NEW MEXICO OIL CONSERVATION DIVISION
 - Engineering Bureau -
 1220 South St. Francis Drive, Santa Fe, NM 87505

OCRID 873
 API # 30-015-32421
 Well Red Lake 3 State #1
 Located E-03-188-28E
 OLD SWD-1365 11/5/12
 7428-7890 1486PX
 WOLF CAMP FM.
 1720 FNL / 1075 FWL
 (E)

RE: Red Lake 3 State #1

Based on the Administrative Order SWD-1365 issued on November 5, 2012, the maximum surface injection pressure is 1486 psi. Apache Corporation respectfully requests to increase the injection based on the 3 1/2" tbg. Step rate tests have been performed and the results are summarized below. More detailed information in regards to the test and wellbore are enclosed.

GROUP:	Permian North	DATE:	Mar. 06, 2013
FIELD:		BY:	SNH
LEASE/UNIT:	Red Lake 3 State	WELL:	#1
COUNTY:	Eddy County	STATE:	New Mexico
API #:	30-015-32421

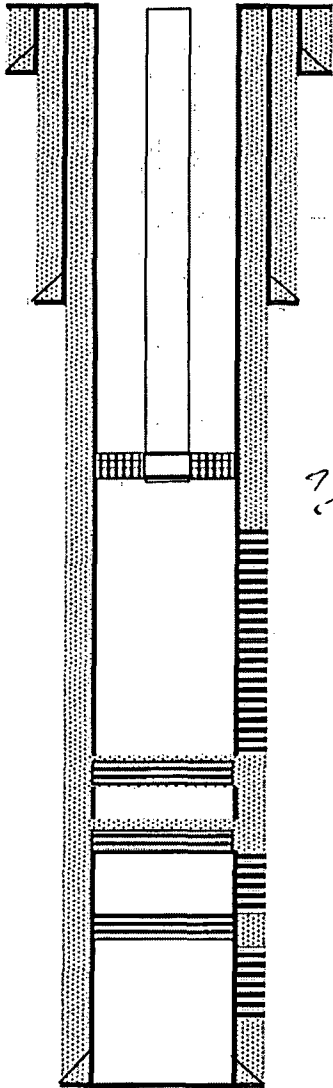
Please send another well bore diagram showing the tubing size (and type) and packer as currently in place in this well.

Also, let me know if the Step Rate Test was run with that current tubing or with a work string (if so, what size and type) or with smaller size tubing (and type). The treatment log had no indication of tubing size or type.

The SRT was run with the new 3 ½ " tubing. Attached is the wellbore diagram with the new tubing and the location of the packer (7540'). I will stick the originals in the mail tomorrow with the packet I e-mailed you the other day.

3-1/2" J-55 TK-Fiberline II Tbg w/turned down collars @ 7543.72'
2-7/8" x 5-1/2" BB 10K 1XN NP PKR @ 7540'

Red Lake 3 #1 - Step-Rate Injectivity - Surface Pressure

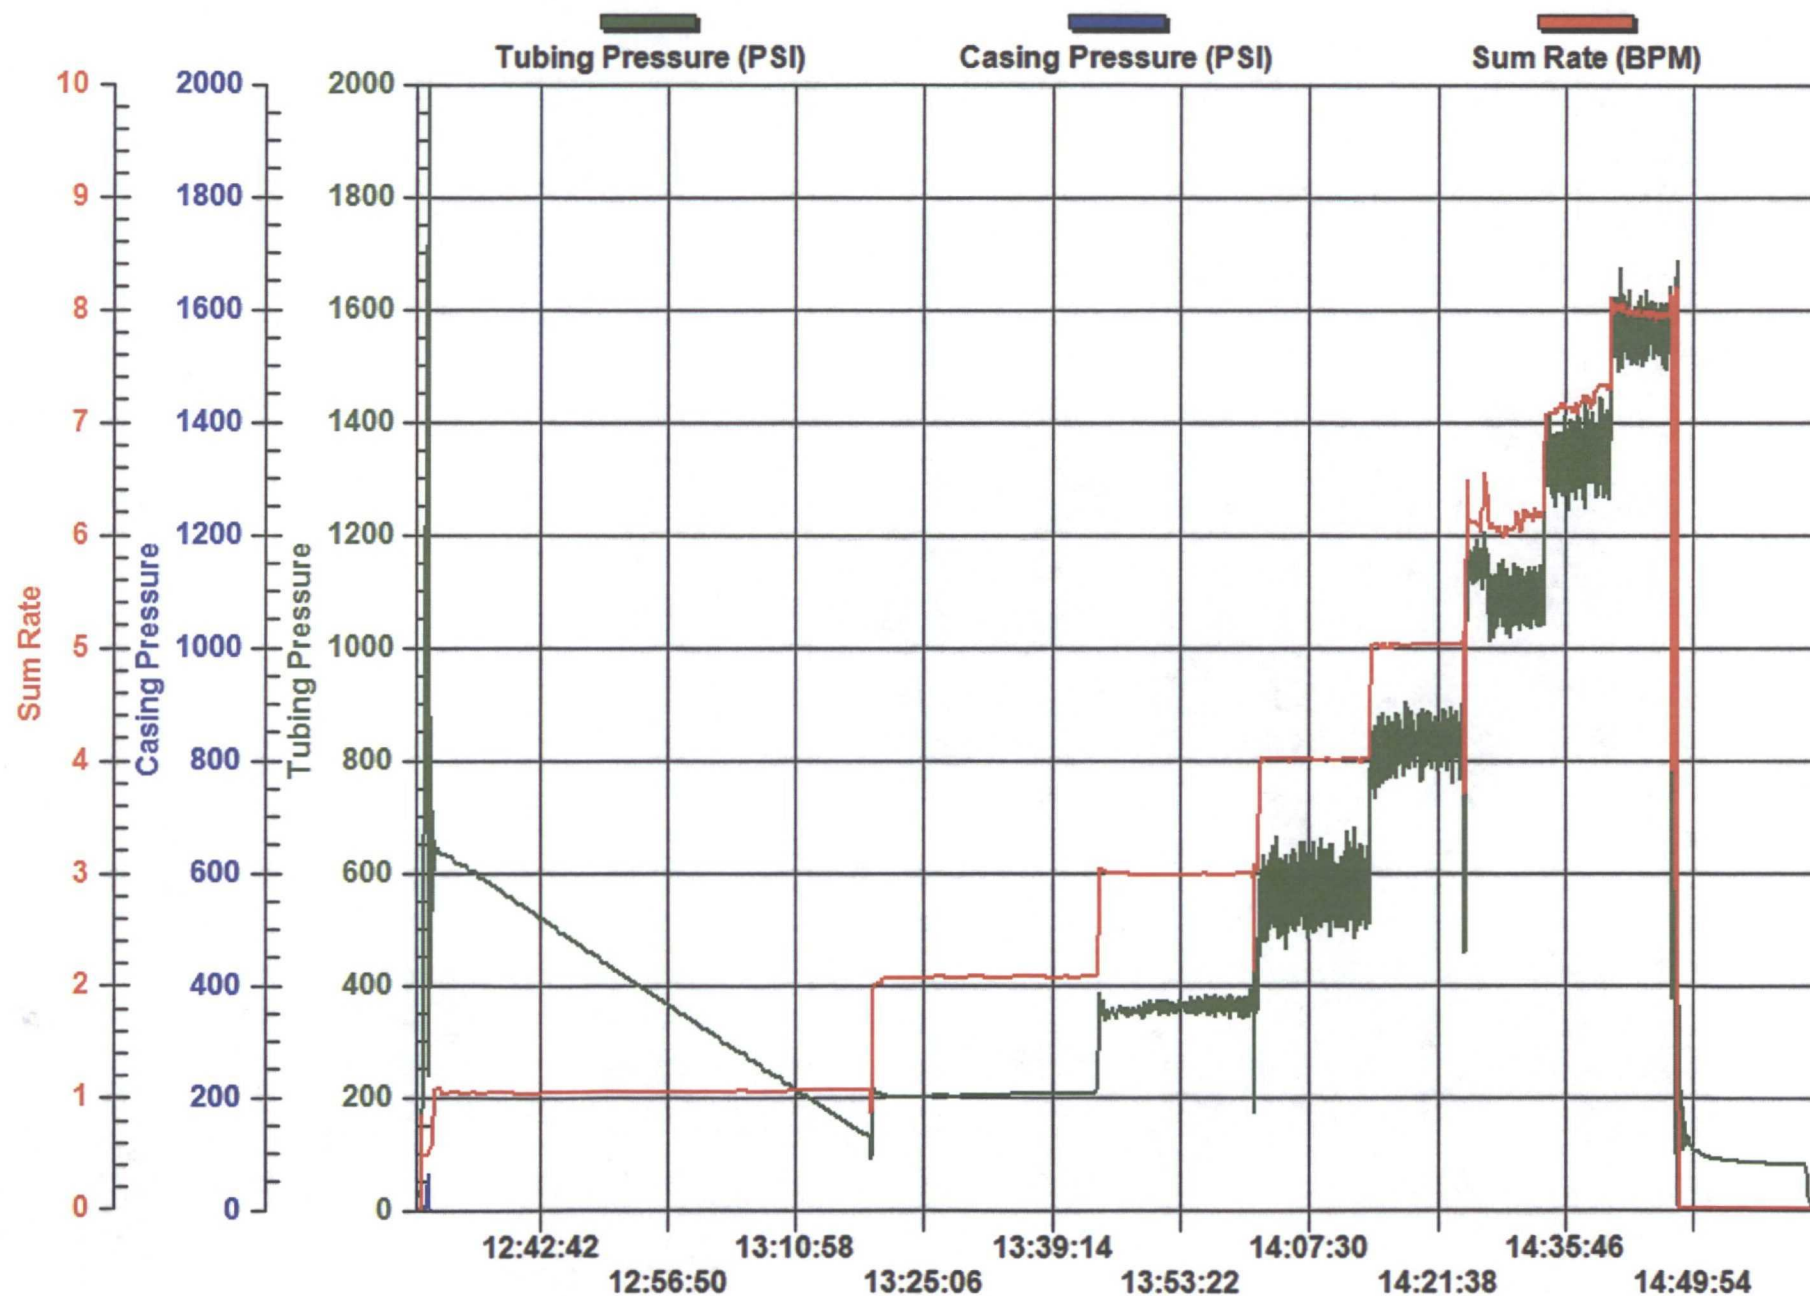
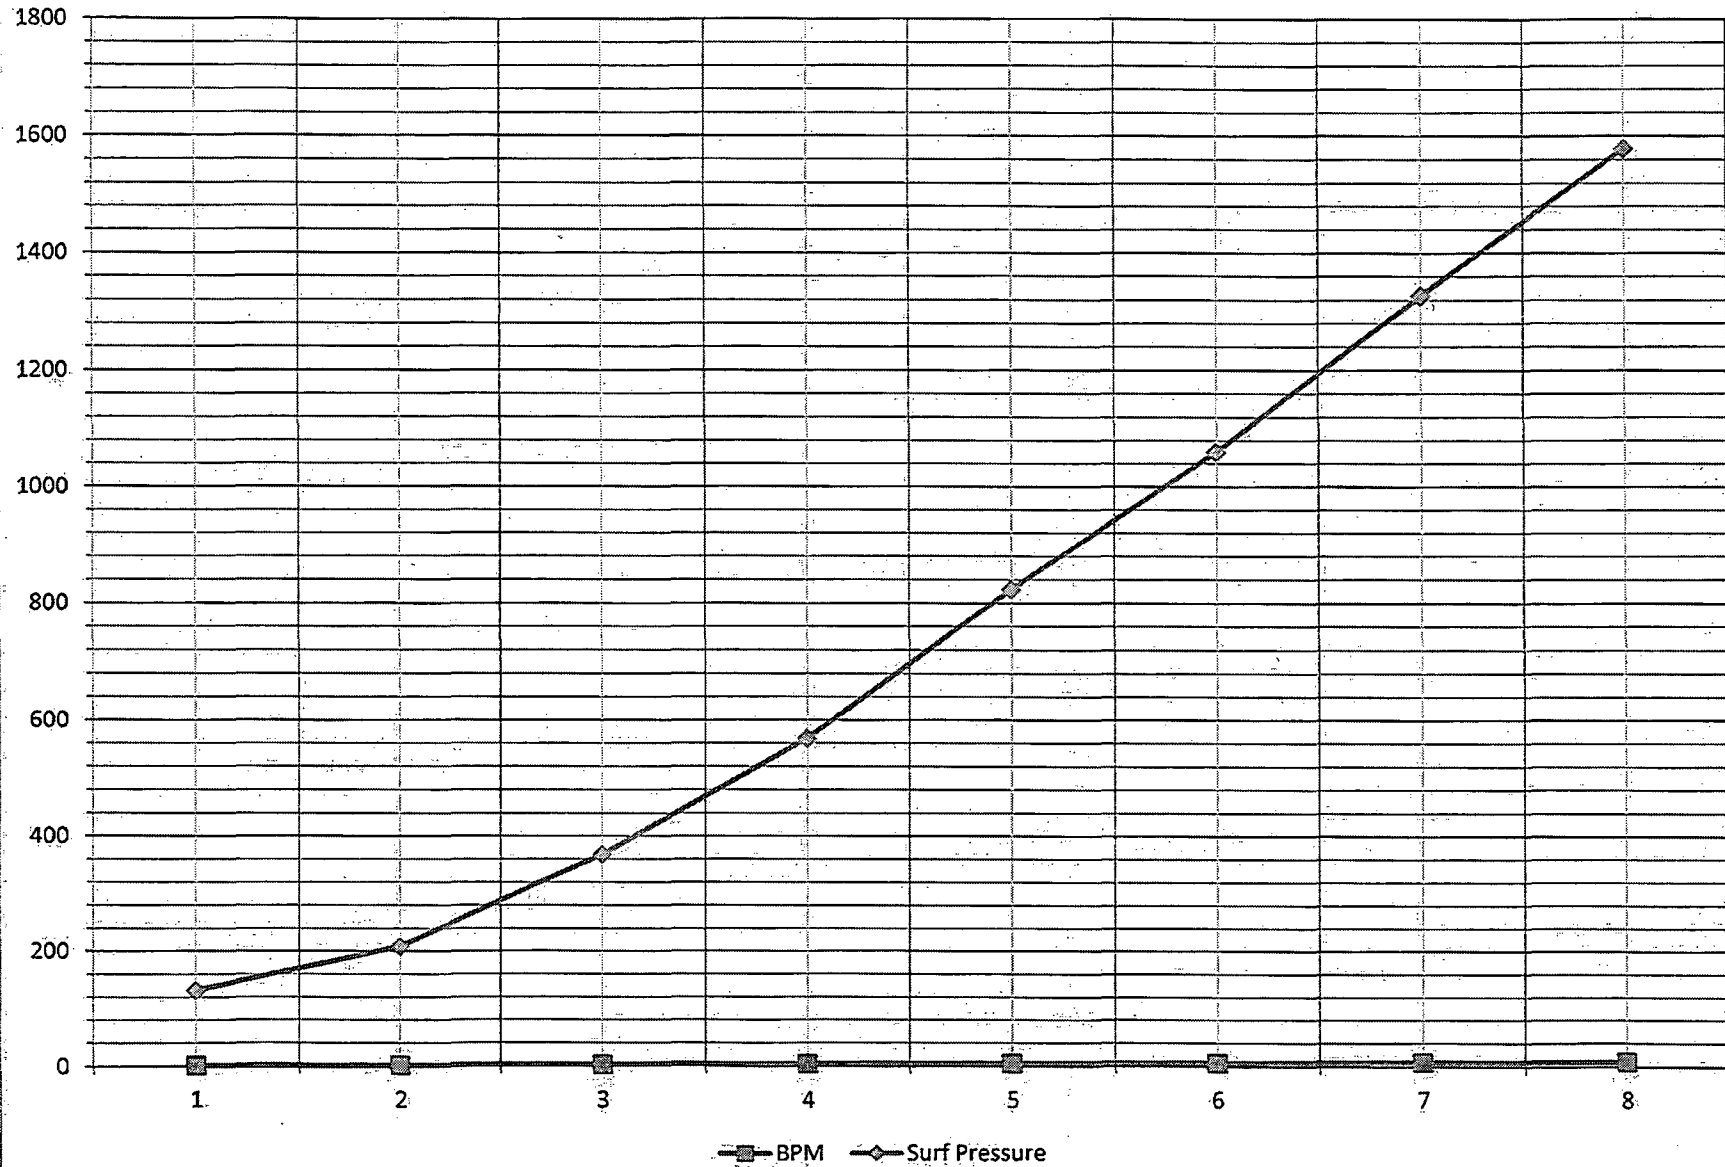
This application is only asking for a slight increase in pressure over the original permit – so not a big deal. However, for future consideration, we “really” like to see bottom hole pressure data on Step Rate Tests. With this high rate and relatively deep disposal, the friction was likely pretty significant. If you had asked for a significant increase in pressure, we would have had you re-run the test with a bottom hole gauge. I think we have mentioned this before.
